Project Name: Olympia Courtyard HotelMaster File: #14-0157☐ Concept Design ReviewDate: November 12, 2015☒ Detail Design ReviewDate: July 27, 2017

**CITY OF OLYMPIA
BASIC COMMERCIAL DESIGN CRITERIA
Chapter 18.110**

NOTE TO DESIGN REVIEW BOARD MEMBERS: THE FOLLOWING DETAIL DESIGN REVIEW STAFF RESPONSES AND RECOMMENDATIONS WITHIN THIS CHECKLIST ARE SHADED

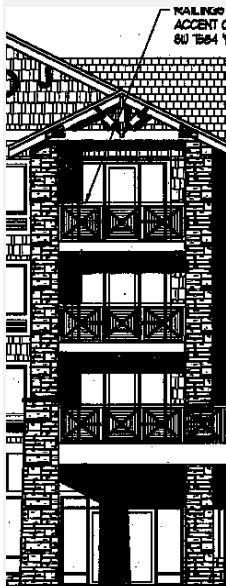
The articulation of the building along the east façade includes a vertical cultured stone section that appears disconnected from the remainder of the building. Modulation and articulation - building sections - should be consistent around the building.

- Roof forms, design features, decks and porches shall integrate as a whole, and shall be uniform and consistent around the building envelope. Exterior finish materials, modulation and articulation shall be coordinated to exhibit a coherent architectural style.

The Lighting Plan, Sheet SP1.1 now includes four types of building mounted and freestanding lighting (also shown on the Site Plan, Sheet SP1.0).

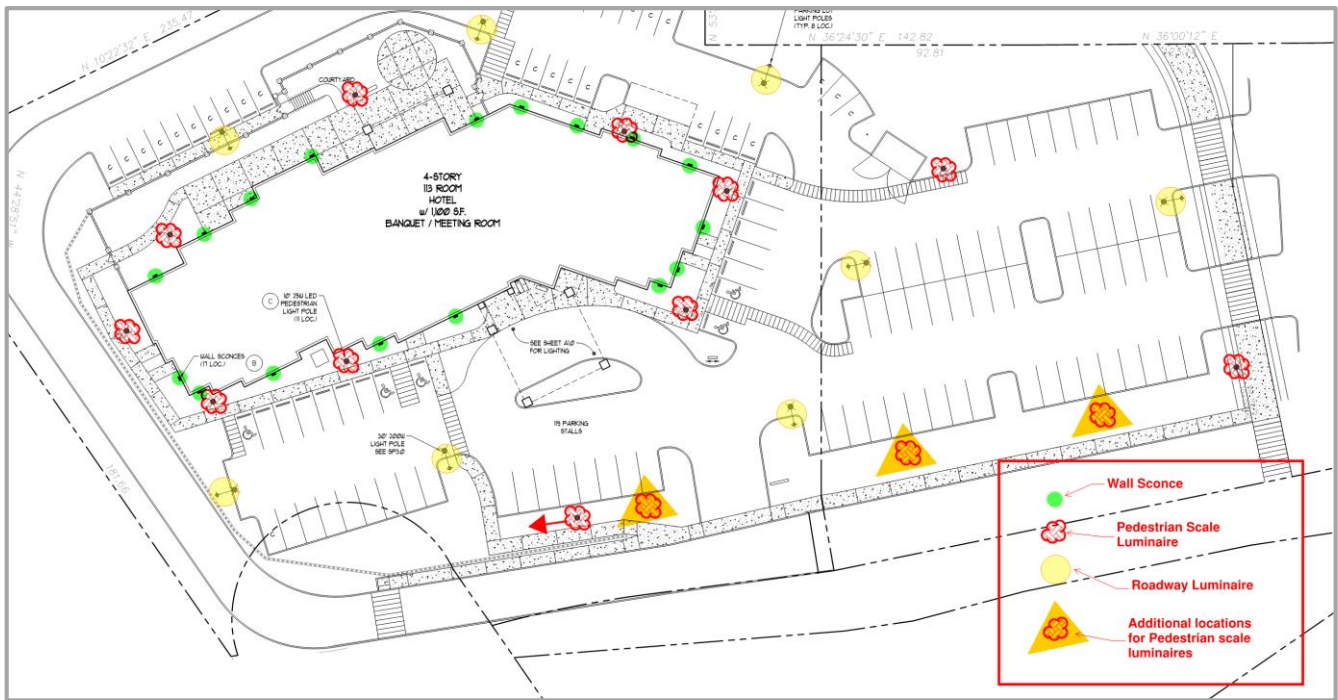
- Sconce lighting on the building, suitable for wet conditions and dark-sky compliant, pedestrian scale lighting.
- Bell-shaped luminaire lighting emits a 5-foot pool of light on the ground with no glare, height dimension in the specifications states a 22-foot height, but the plans show a height of 10 feet...? The manufacturers cut sheets suggests 8-10 foot spacing.
- Can recessed lighting under the Porte Cochere and under the patio cover near the rear courtyard, 600 lumens or approximately equivalent to a 60W bulb.
- Eight (8) Roadway luminaires heights of 25 feet and 30 feet. Explain the difference in heights - may be an oversight, may have 25-foot-tall lamps on the west side of the site along the Freeway...

The length of the walkway from the north property line, between the two hotels, and the southeast corner of the development (parking lot) is approximately 200 feet on the northeast side of the entrance, and approximately 135 feet south of the driveway entrance. However, only two pedestrian scale luminaires are located along this expanse of walkway - not entirely safe or comfortable for pedestrians at night.

- Provide more bell-shaped lighting along the Henderson Park Lane SE sidewalk, on both sides of the main driveway entrance (refer to the graphic below).
- Direct parking lot roadway luminaires away from I-5 and expressly on-site.
